Graviton Rev. 2B change requests

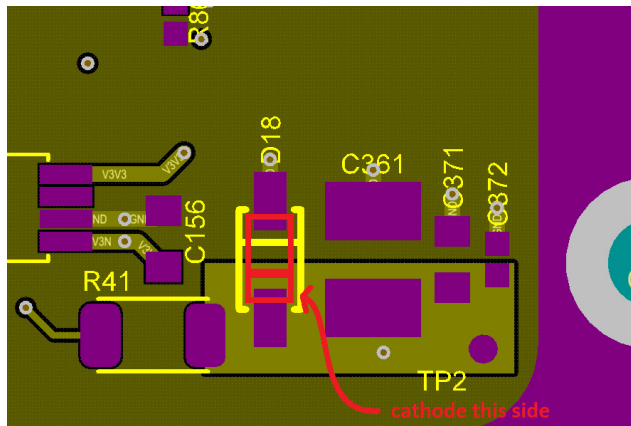
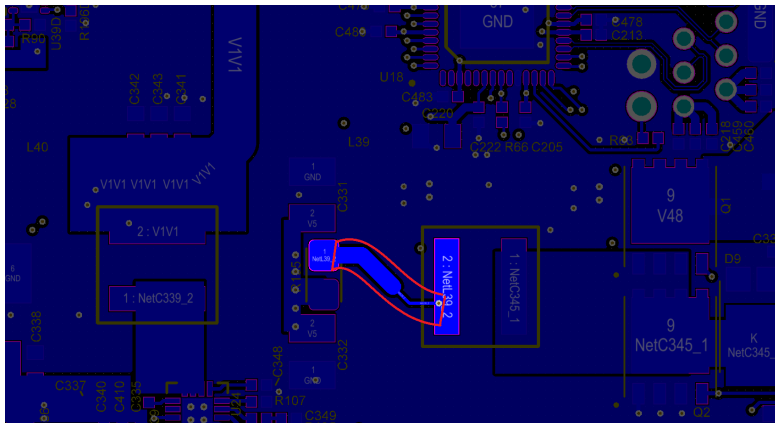
1. Change connector J10 from right angle (P/N S8B-ZR) to thru-hole (P/N **B8B-ZR**). *This part needs to be ordered.*
2. C361 is too tall. Change C361 (P/N GRM32EC81C476KE15L) to P/N **EMK325BJ226MD-T**. *This part needs to be ordered.*
3. R195 was loaded with the wrong part. Should be P/N CSR1206-OR007F1. See Tina for more details.
4. Zener diode D18 is backwards. Please rotate.

5. 5V trace too thin yielding incorrect current measurements. As a result, this is causing instability in the 5V supply. Please use a piece of wick (copper braided wire), copper film, wire, or other thick conductor to bridge L39 to R195. The connection needs to be less than 1mOhm. As a suggestion I recommend removing L39, adding the conductor, and then re-installing L39.

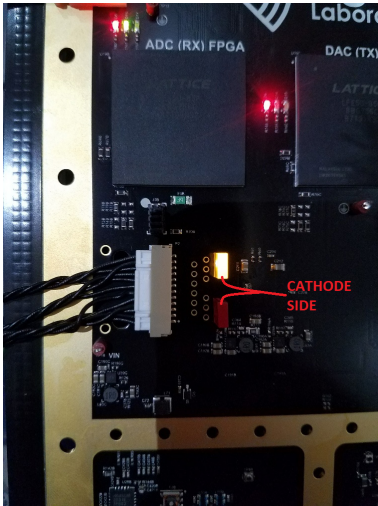
6. Add two thru-hole LEDs as shown below

orange and red LEDs to be provide to SEM by Signal Laboratories.
